"cbmSD-mini" V1.2

cbmSD-mini Ver 1.2

Title: cbmSD-mini

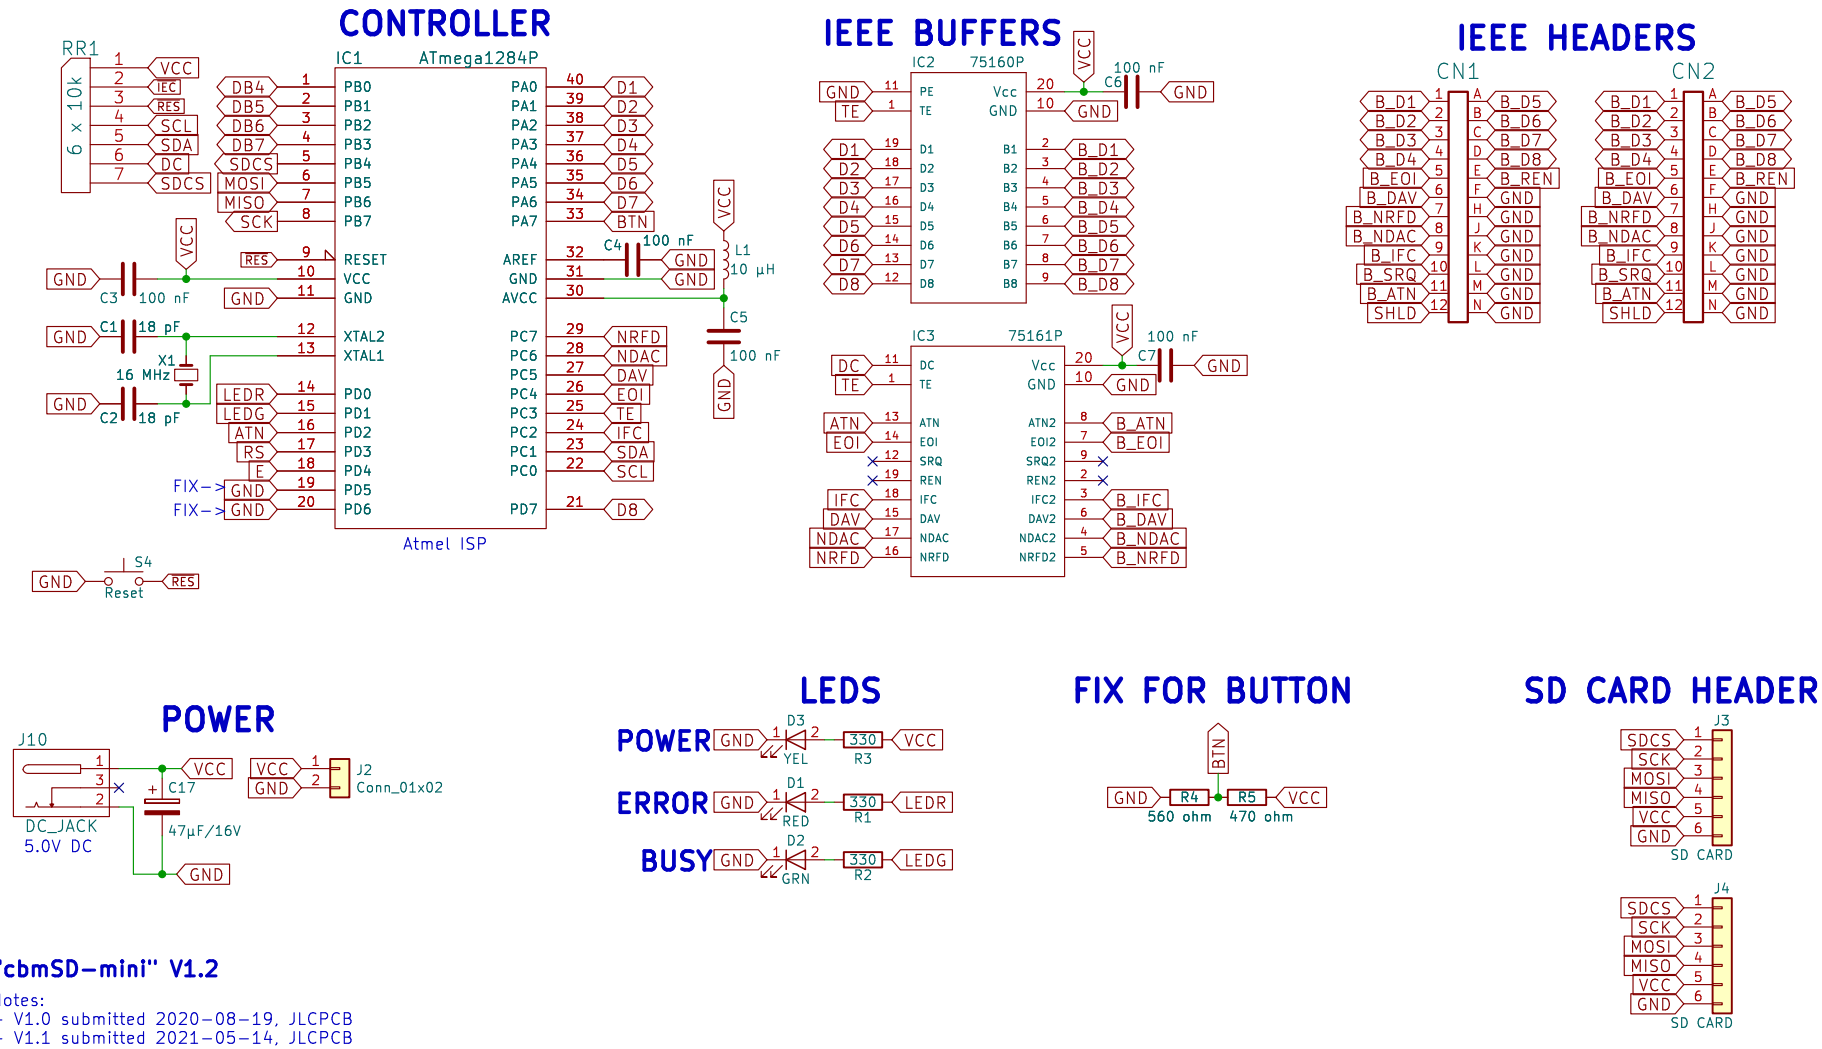
Changes:
1. Remove 74HTC125 - no IEC, so not required.
2. Remove JTAG
3. Fix routing error on power led footprint
4. Move J2 header closer to IEEE to allow horizontal pins
5. Shift reset button slightly back from edge.
6. Add mounting/support hole for SD card.
7. Add mounting hole at reset corner.
8. Add second CARD header for mounting card facing outwards.
